Re: Objection to the Mad Rabbit Trails Project #50917

Keep Routt Wild (KRW), through its undersigned attorneys, submits this objection to the Mad Rabbit Trails Project #50917 (Project) in the Routt National Forest (Forest) pursuant to 36 C.F.R. Part 218. In addition to previous comments in the record with the Forest Service on this Project, *see* Exhibit A, KRW submitted written comments on the Draft Environmental Assessment (DEA), describing the inadequacy of the agency's analysis of the proposed action under the National Environmental Policy Act and its concerns about the negative effects of the proposed action.¹ Although the Forest Service's Final Environmental Assessment (FEA) and draft Finding of No Significant Impact (FONSI) have several changes compared to the DEA, the environmental assessment still fails to "[b]riefly provide sufficient evidence and analysis for determining whether to prepare an environmental impact statement or a finding of no significant impact." 40 C.F.R. § 1508.9(a)(1) (1978).

Image above shows the cumulative elk habitat disturbance of the proposed action over the project area

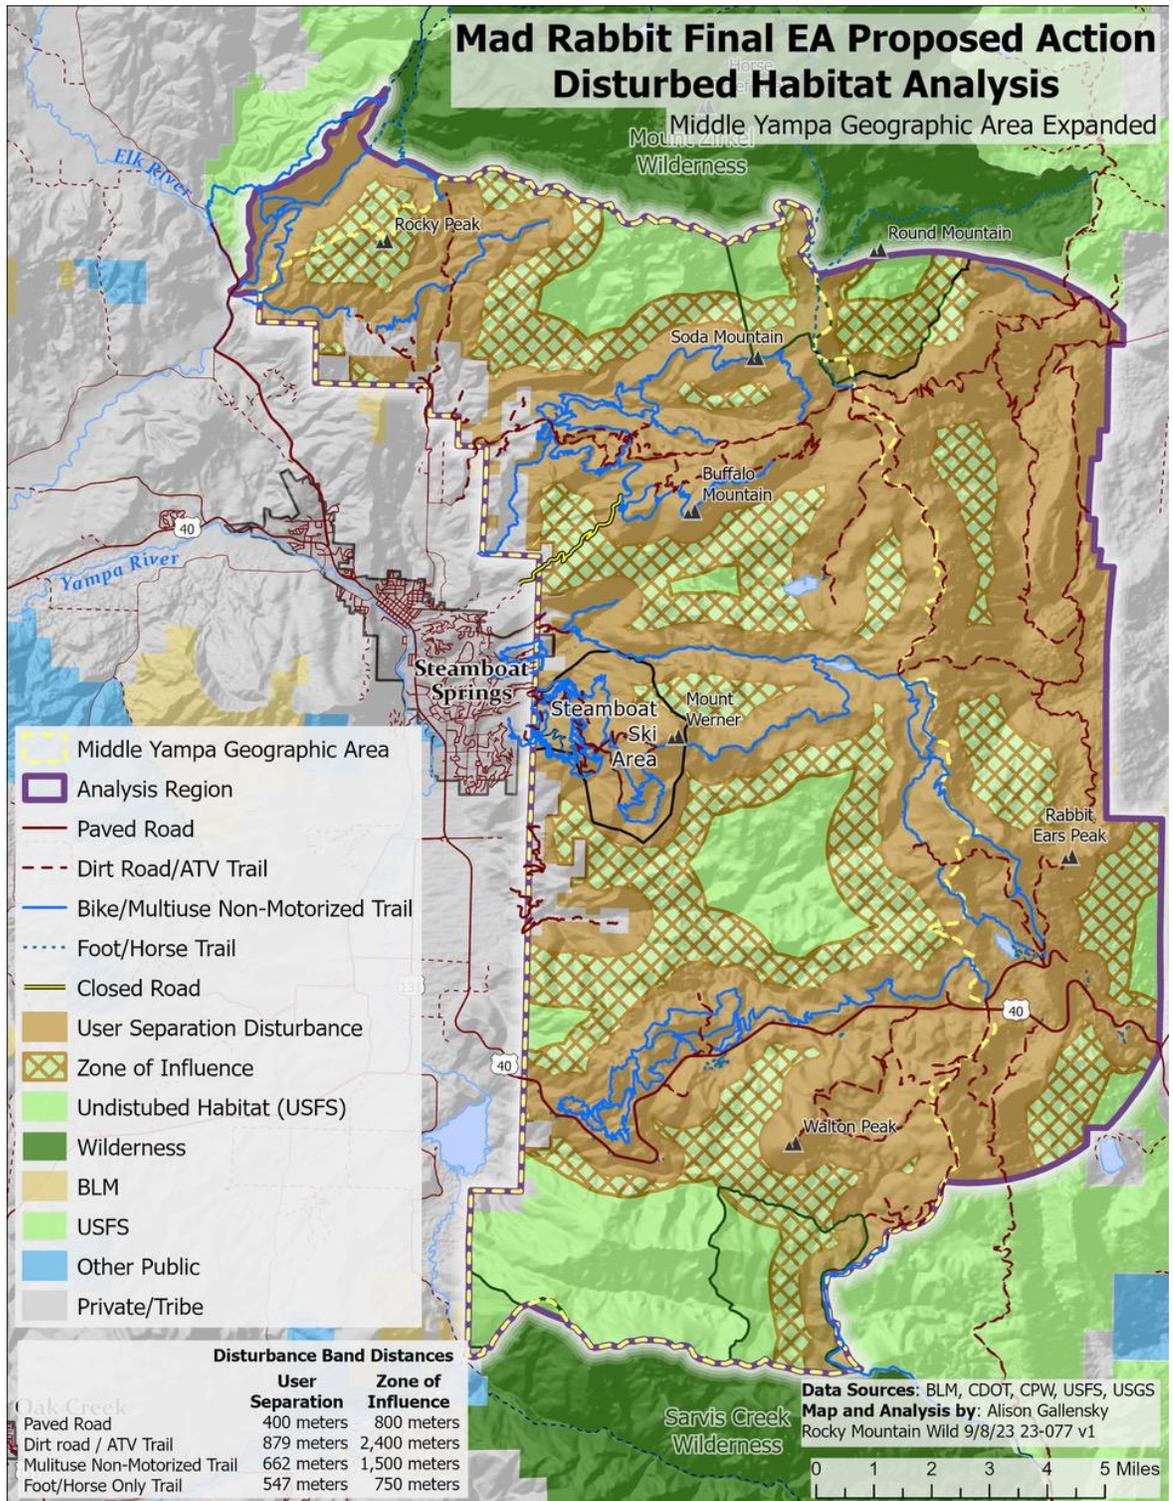
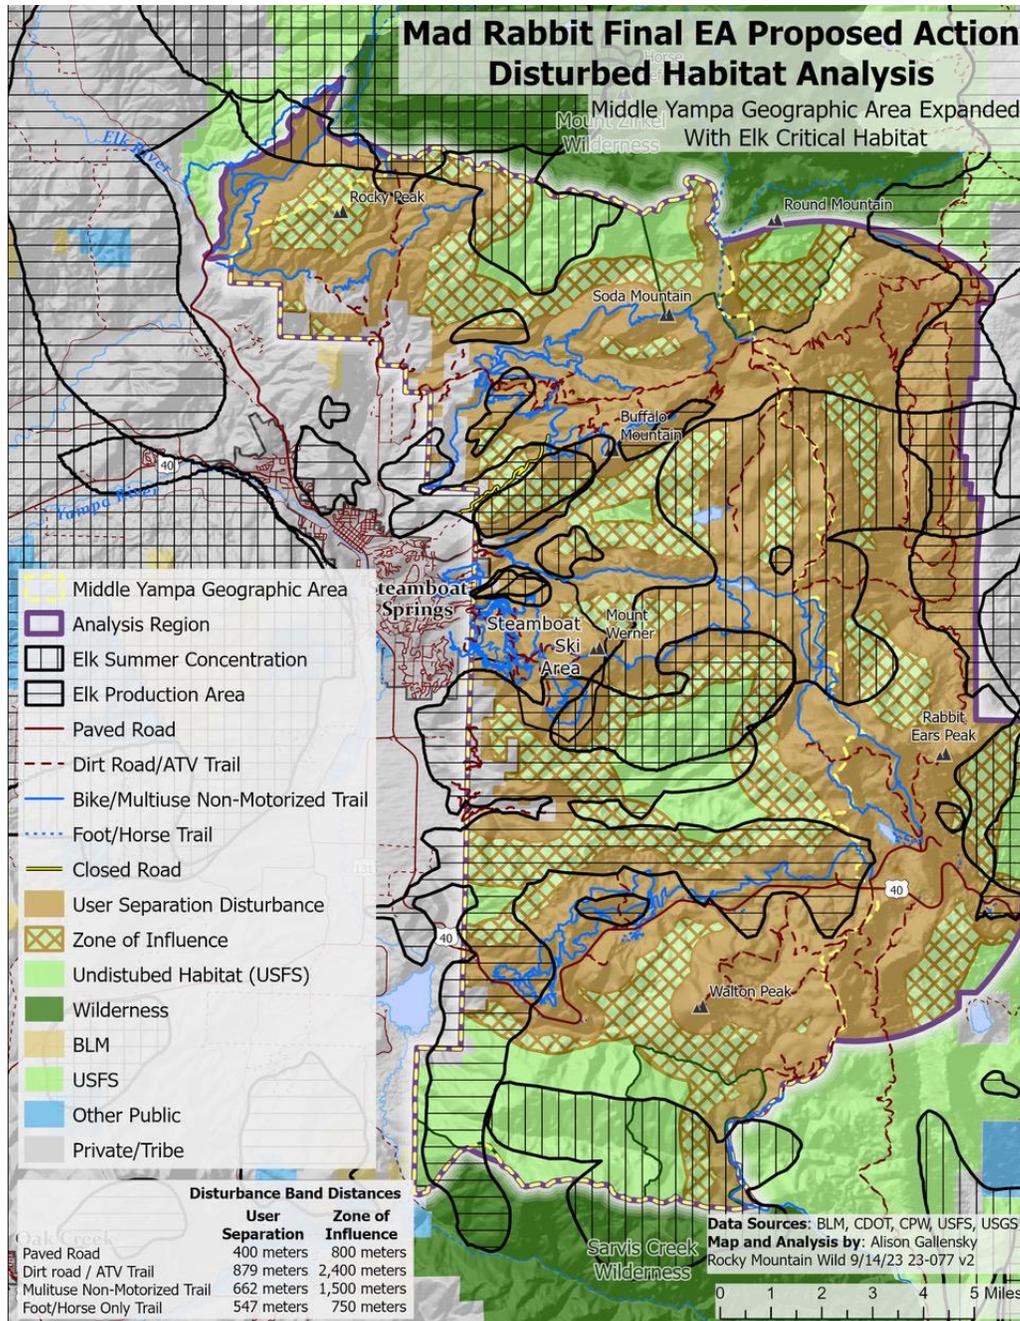
Equally important, contemporary methodologies, like that shown above, indicate elk HE is more challenged than the FEA suggests. KRW, in cooperation with Rocky Mountain Wild, performed a GIS analysis of the project area with respect to elk HE. See Larry Desjardin *et al.*, [*Recreational Disturbance Modeling of Elk Habitat in Medicine Bow-Routt National Forests*](#) (Feb. 19, 2022). The analysis found that it is likely that the elk HE metric of 50% is not being met in either the Middle Yampa Geographical Area (MYGA) or the project area, and that the Mad Rabbit Trail Project will lower elk HE further below the Forest Plan’s standard.

The analysis was updated to reflect the proposed action in the FEA. It found that over 3900 acres of habitat are lost due to the proposed action. It also found that 53% of the MYGA landscape was heavily disturbed, as defined by the user separation disturbance metric, and an additional 29% was in the Zone of Influence, a partially disturbed area where elk may flee. Only 18% was undisturbed. This leads to a high probability that elk HE is well below the 50% Forest Plan standard.

A map showing the habitat disturbance by the proposed action is below. Together, the user separation disturbance (solid brown) and the zone of influence (crosshatch) give insight into the impact of human activity on elk habitat. Solid green shows undisturbed habitat. The user separation distance defines a high-avoidance area on both sides of a trail or road where elk habitation rates are very low compared to their natural state. The zone of influence is farther from a road or trail, where habitation rates may be lower than the natural state, but not as low as the user separation disturbance.

The second map below is the same map of human disturbance overlaid with CPW-identified elk production areas and elk summer concentration. The GIS analysis makes clear that there are concentrated disturbances in identified elk habitat areas. The analysis also shows the important value geospatial analysis brings to modern elk habitat effectiveness analysis techniques compared to the simplistic method employed by the Forest Service where the location of the disturbances is disregarded.

Figure above shows the measured calf:cow ratio in GMU 14. Courtesy of CPW.

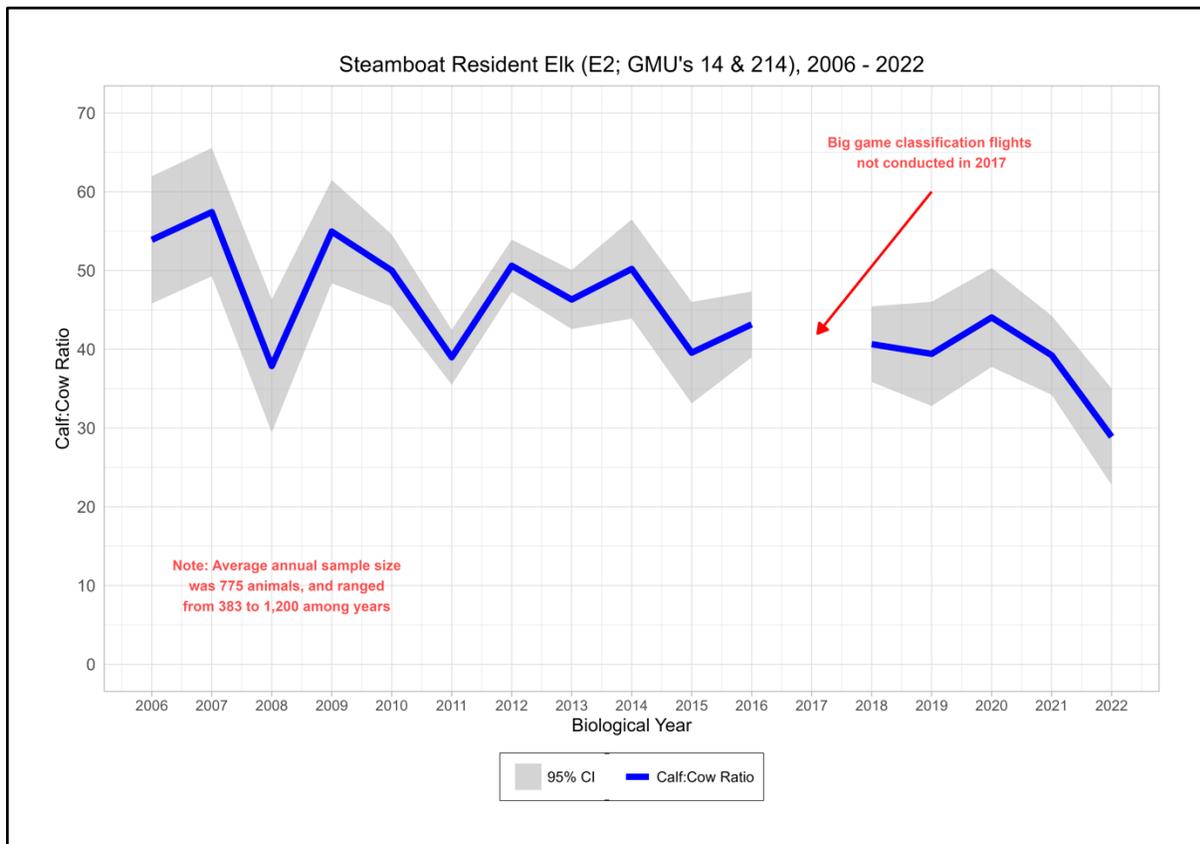
Over the past fifteen years, there has been a decrease in both the classified population of the resident herd and the associated calf:cow ratio. *See* FEA at 56 (noting local elk herds “have been displaying what would be considered a decreasing trend in both number of elk classified and calf:cow ratios”); *see also* [CPW Commission Issue Paper](#) at 13 (Nov. 2021) (showing the decline in the resident elk population from approximately 750 to 510 individuals from 2006 to 2019). Most concerning, there is a precipitous decline in the calf:cow ration in GMU 14. There is little doubt that this lower calf:cow ratio is driven, in part, by the high degree of recreational development in GMU 14 on Forest Service lands. However, while GMU 14 data is mentioned in the FEA, the cumulative impacts to the herd are only mentioned qualitatively.

Figure above shows the estimated population of the E-2 herd. Courtesy of CPW

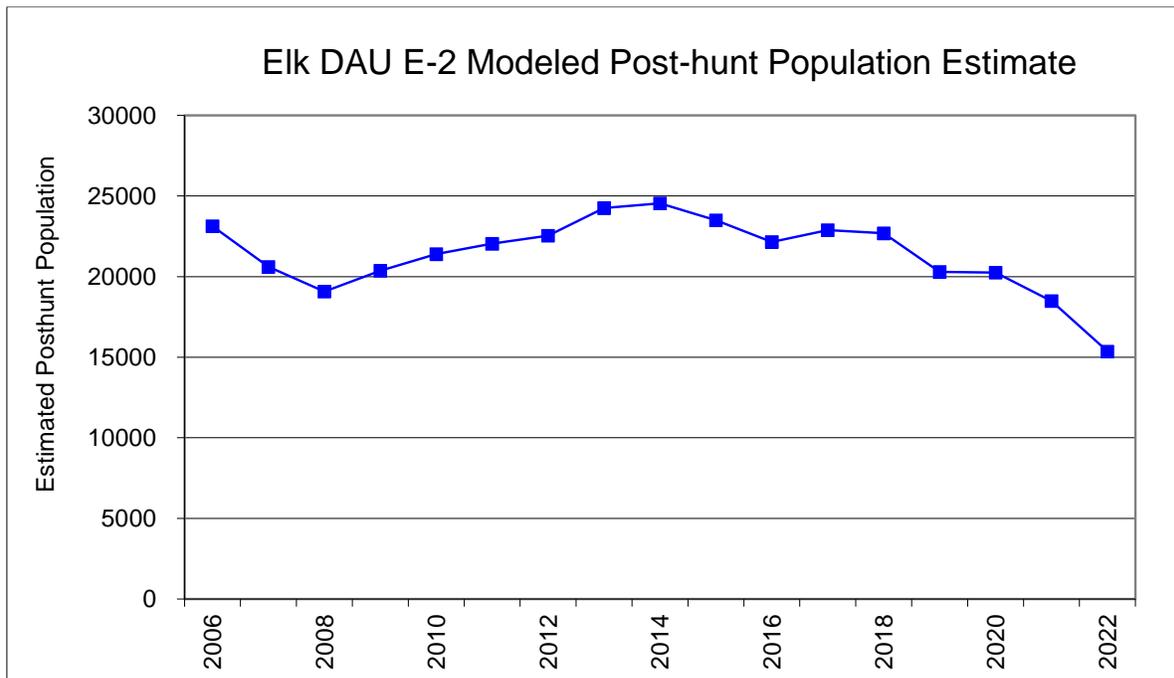
Moreover, the FEA does not include the latest data on the E-2 herd. The figure below, from CPW, shows the most recent population estimates of the E-2 herd, and a worrying steep decline in the post-hunt population estimate. This places the E-2 herd only slightly above the lower limit of the E-2 population objective of 15,000 elk, and with a steep decline.
